WIRING DIAGRAM FOR FA-1 FOR PROPER FUNCTION OF RCC & DCC SYSTEMS

Improper Arrangement of Motor Block Wires on PCB-2

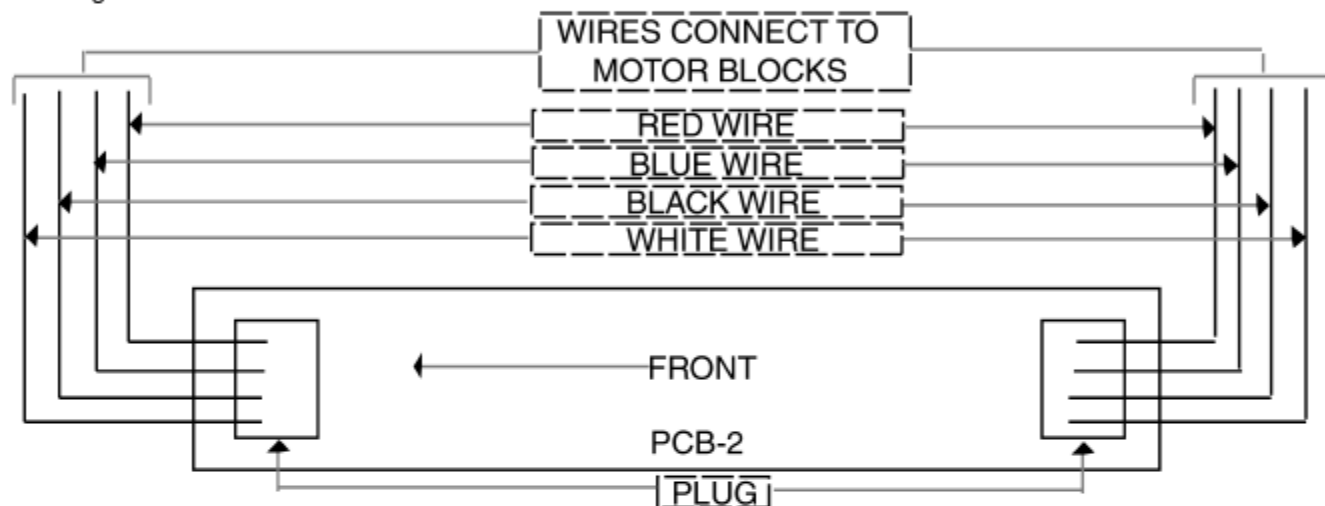
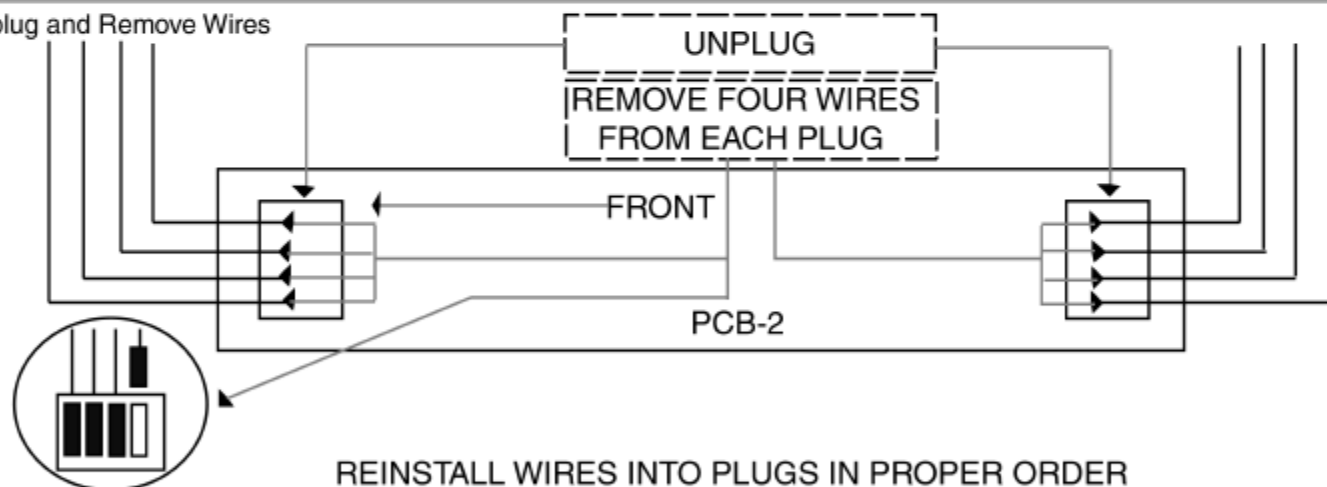
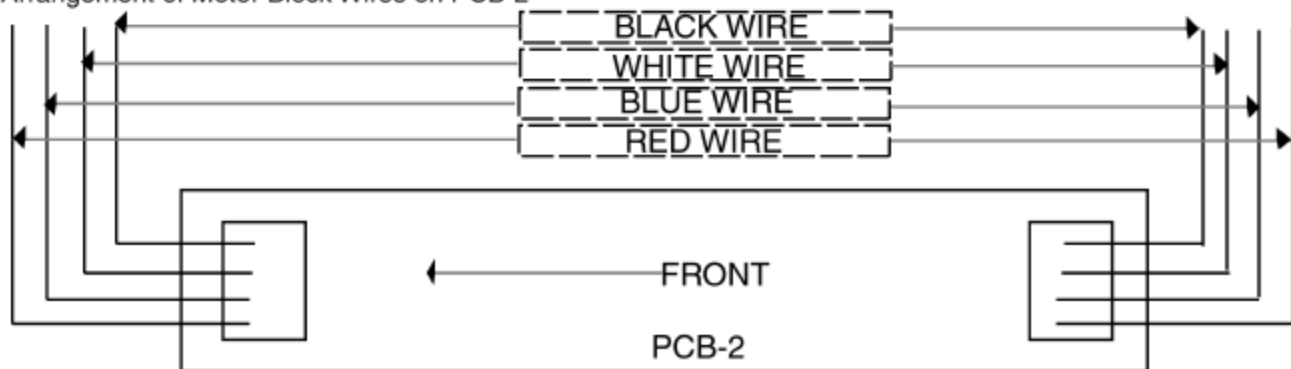
Some FA-1's with the new "Plug and Play" (PCB-1) PC Boards manufactured in late 2001 and early 2002 may have improper wiring. The wires from the motor blocks may have been improperly installed in the plugs on the PCB-2 "Bus Board". The wires from the motor blocks are color coded. Inspect the wires at the plug on the PCB-2. If the order of the wires is RED, BLUE, BLACK, WHITE, the wiring is improper. The proper order of wires from the motor blocks should be BLACK, WHITE, BLUE, RED. This is easily corrected by unplugging the motor block plugs from the PCB-2, removing the wires from the plugs, and reinstalling the wires in the proper order. Then plug the plugs back into the PCB-2.

2 Unplug and Remove Wires

To remove wires from plugs: Use a large needle or a nail to push down on the wire tab in the plug. Pull the wire up and out of the plug. Reinstall the wire by pushing the wire down into the plug.

REINSTALL WIRES INTO PLUGS IN PROPER ORDER

3 Proper Arrangement of Motor Block Wires on PCB-2
